RE: **Lot 14 Block 7A S.A.D. 227 Unit 3**
6119 Little Joe Dr.. NW
Grading and Drainage Plan
Engineers Stamp Date 5/13/2020 (E10D078)

Ernest Armijo, P.E.
Principal Engineer, Planning Dept.
Development Review Services

DRAINAGE AND TRANSPORTATION INFORMATION SHEET (REV 6/2018)

ENGINEER'S SEAL	6119 LITTLE JOE PLACE	DRAWN BY WCMJ
		DATE 5-12-20
5/13/20	GRADING AND DRAINAGE PLAN	2102037-LAYOUT-5-12-20
DAVID SOULE P.E. #14522	 <i>Rio Grande Engineering</i> 1606 CENTRAL AVENUE SE SUITE 201 ALBUQUERQUE, NM 87106 (505) 872-0989	SHEET # —
		JOB # 2102037

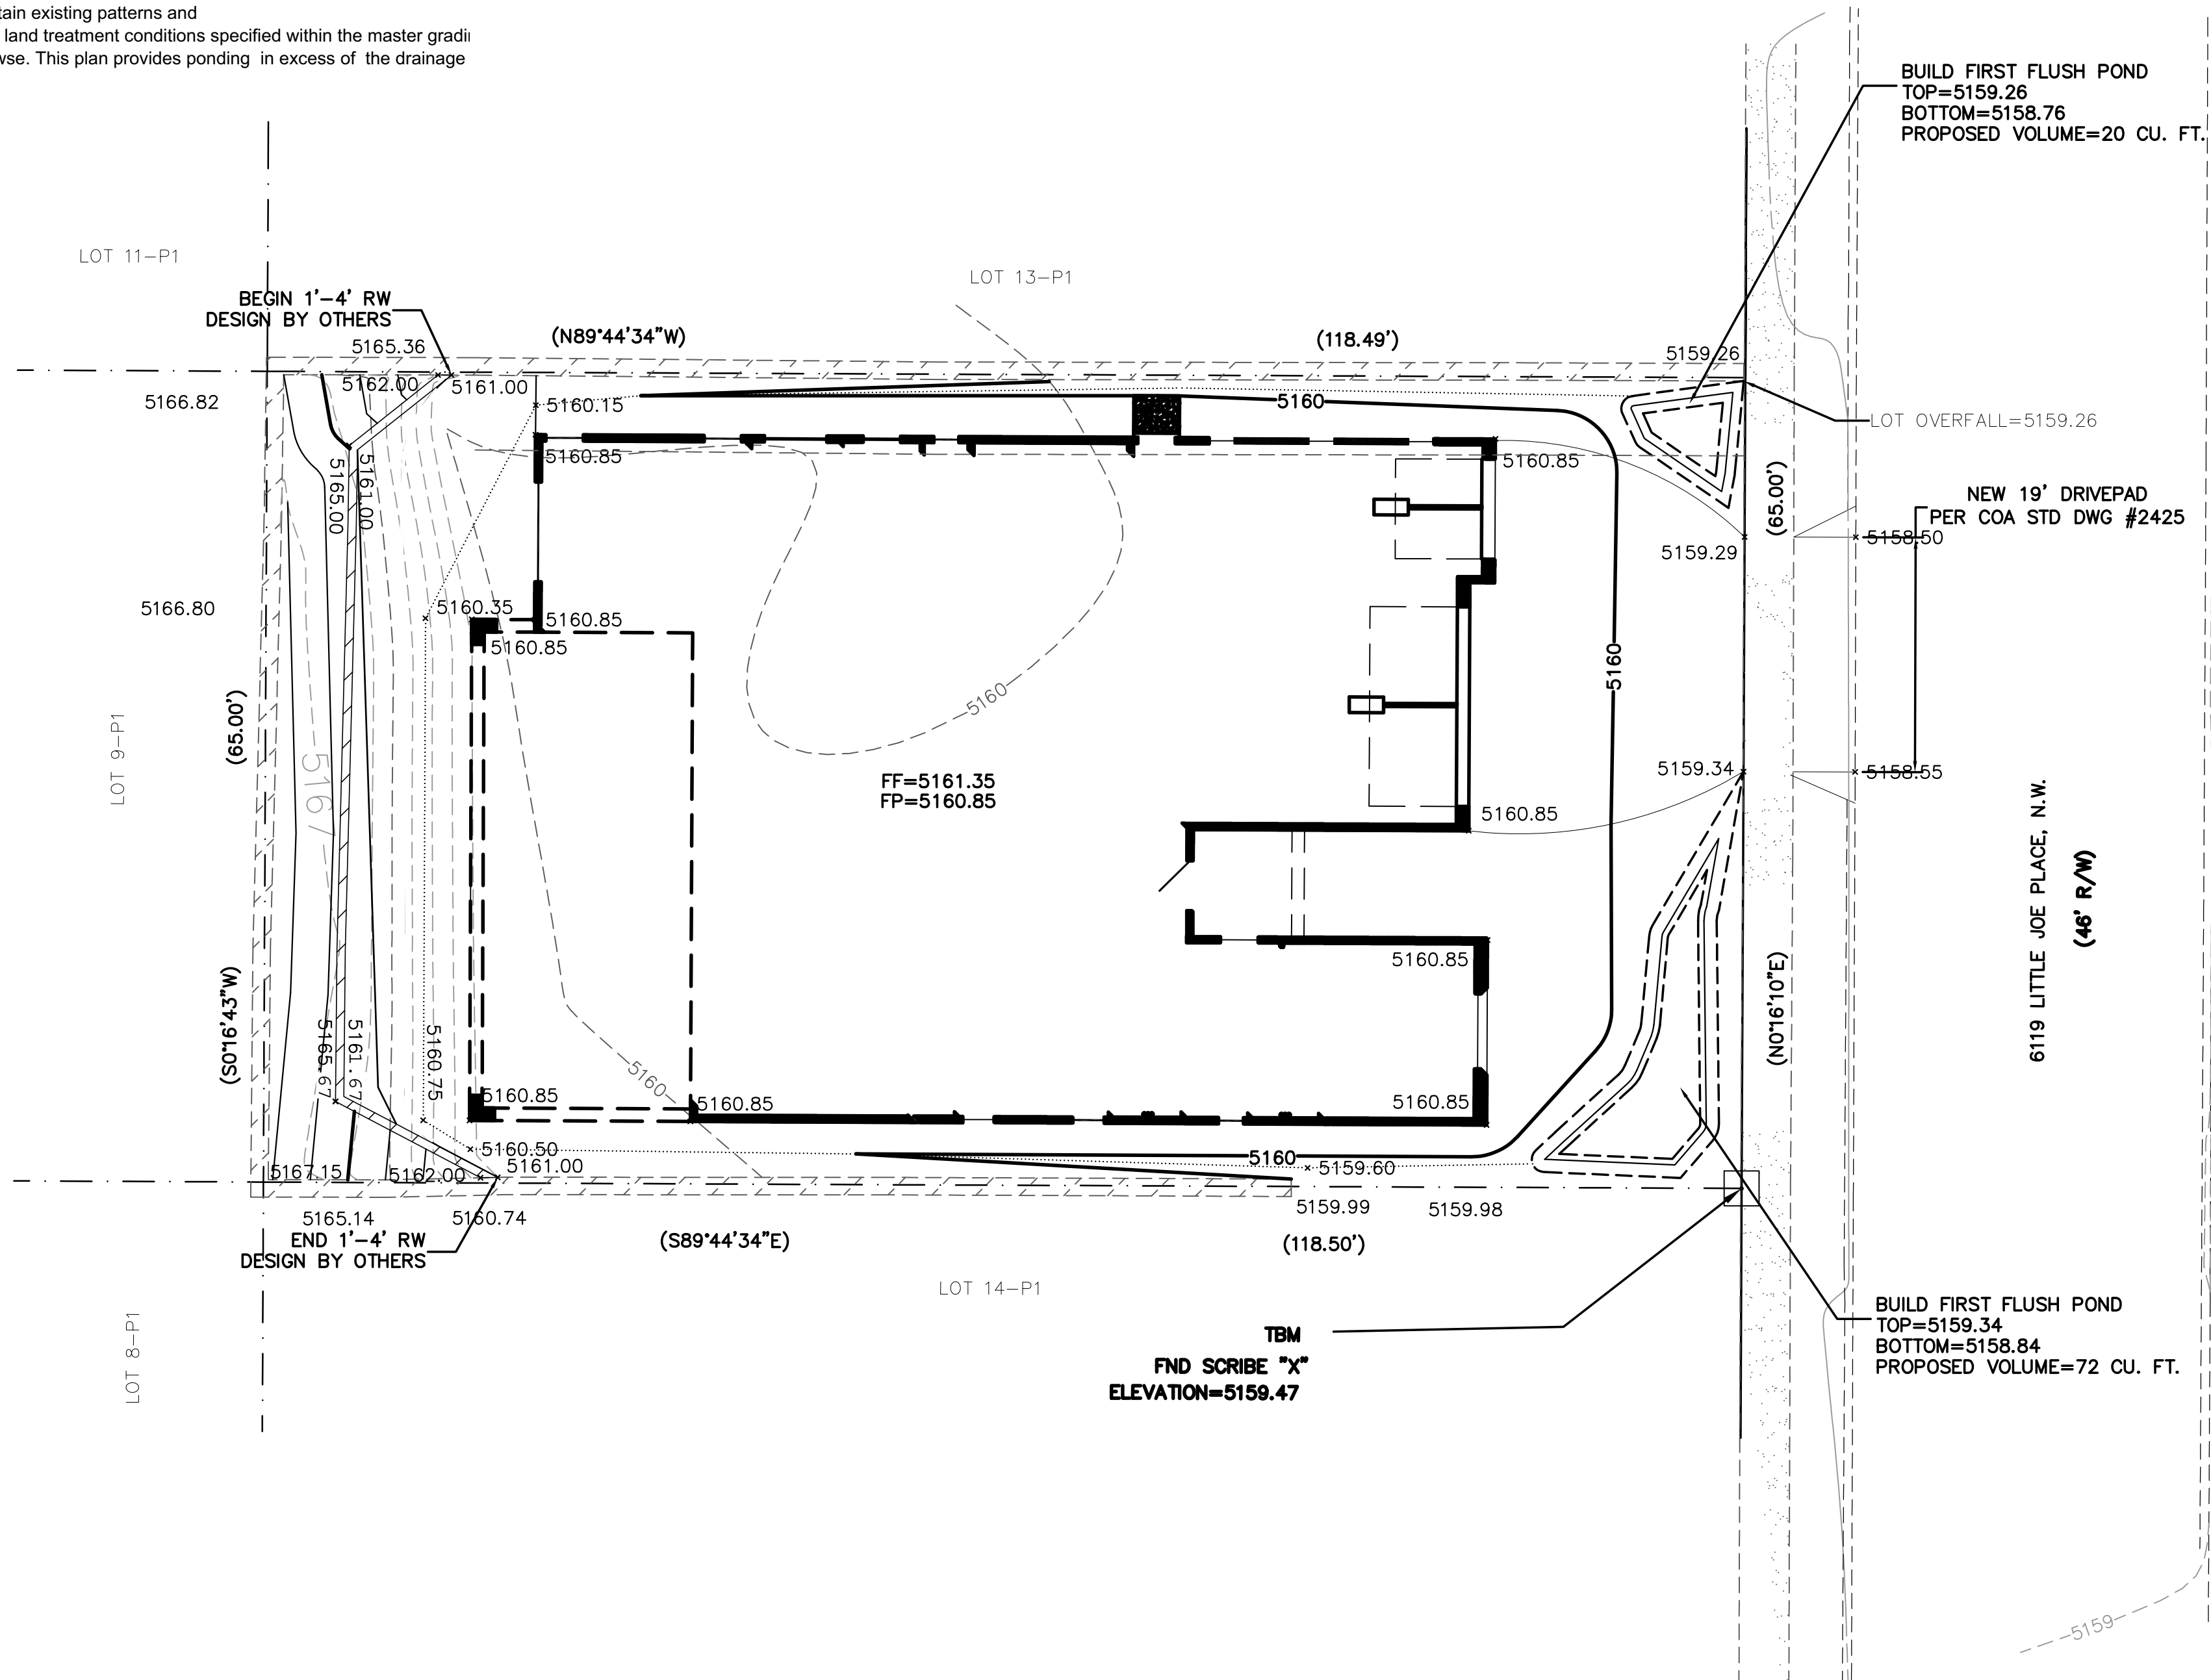
Based upon the information provided in your submittal received 5/14/2020, this plan is approved for Grading Permit. Please inform the builder/owner to attach a copy of this approved plan and letter into the construction sets in the permitting process prior to sign-off by Hydrology.

Reiterate to the Owner/Contractor that a separate permit for any garden/retaining wall must be obtained, with the approved G&D plan.

Prior to Building Permit approval, a **Pad Certification** will be required. Inform the contractor/owner not to pile dirt in the street as a ramp to climb the curb. If dirt is found in the street the pad cert. will be denied.

Prior to **Certificate of Occupancy release**, Engineer Certification per the DPM checklist of this plan will be required.
